FUSELAGE - RADOME LATCH IMPROVEMENT

MODEL	SERIAL NUMBERS
525B (CJ3)	-0057, -0451 thru -0636

SB525B-53-03
Page 1 of 5

Figure 1. Radome Latch Installation (Sheet 1)

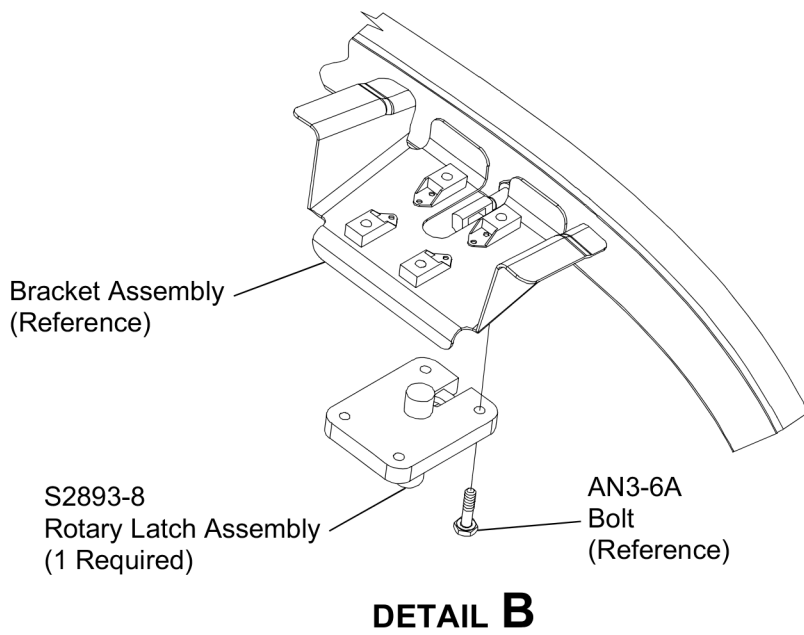
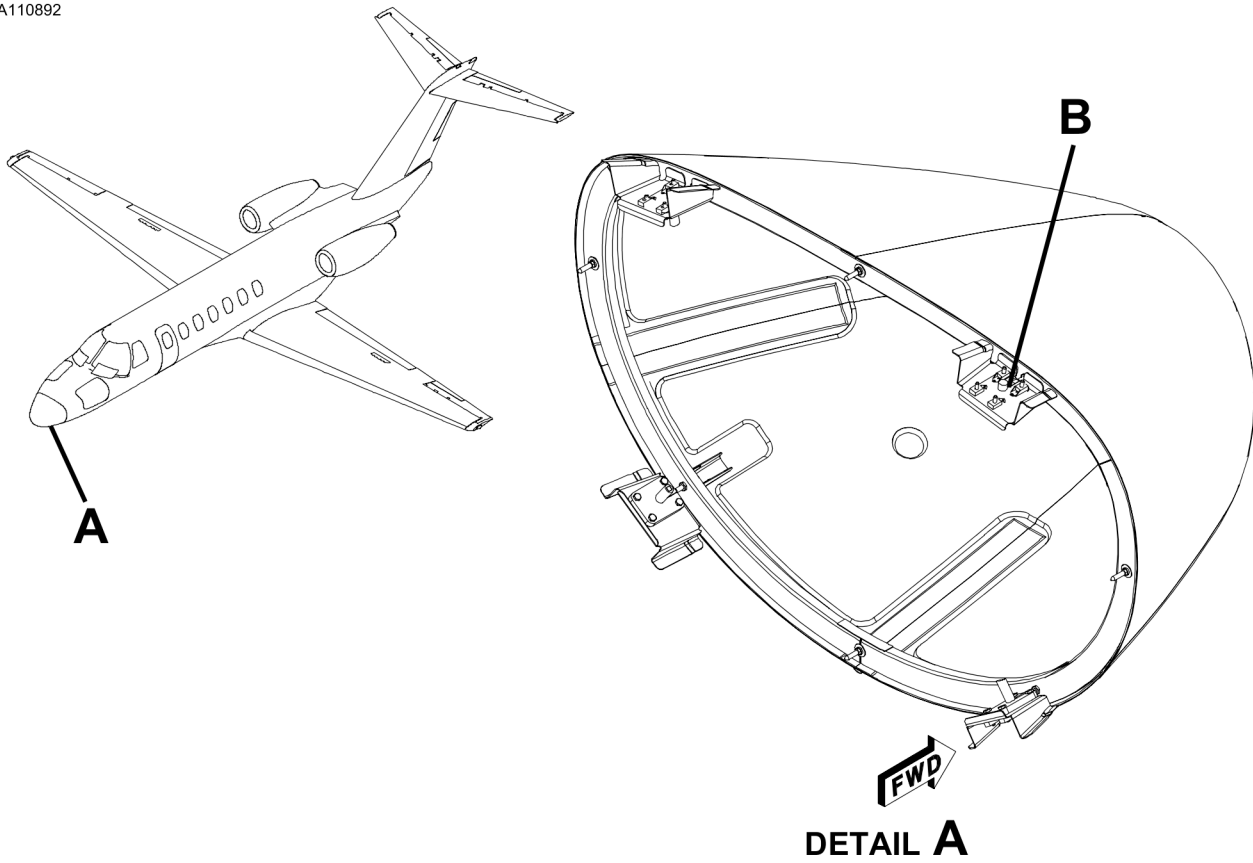
The current latch may be difficult to access with Garmin avionics boxes installed.

This service bulletin provides parts and instructions to replace the current latch with a shorter latch.

5. Remove and discard the S2893-15 Rotary Latch Assembly.
6. (Refer to Figure 1). Install the new S2893-8 Rotary Latch Assembly using the retained AN3-6A Bolts.
NOTE: Install S2893-8 with the latch opening facing forward.
